Amendment to the Drawings:

REMARKS

FIG. 6

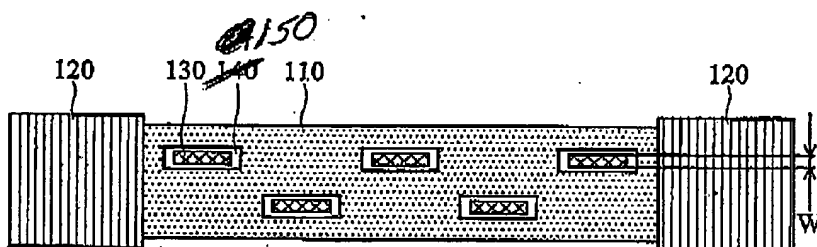
The attached sheet of drawings includes a change to FIG.6, in which reference numeral 140 is replaced by 150. This sheet, which includes FIGs. 5 and 6, replaces the original sheet including FIGs. 5 and 6.
